Access Compliance Report Public Rights-of-Way (Pedestrian Signals)

Main Street: **NEWPORT_AVE** Cross Street: **NEWPORT_AVE** Location: **N**

ADA ID: **SGRK211007135145** Signal Type: **One Push Button-APS** Overall Compliance: **No** Severity Scores: **BTN 1: 45** **BTN 2: N/A** **No BTN: N/A**

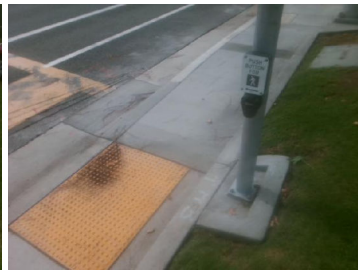
OC Std/PROW: MUTCD 4e.08, R404.2

Possible Solutions: Replace Signal Push Button With APS Button. Remove & Relocate Sign.
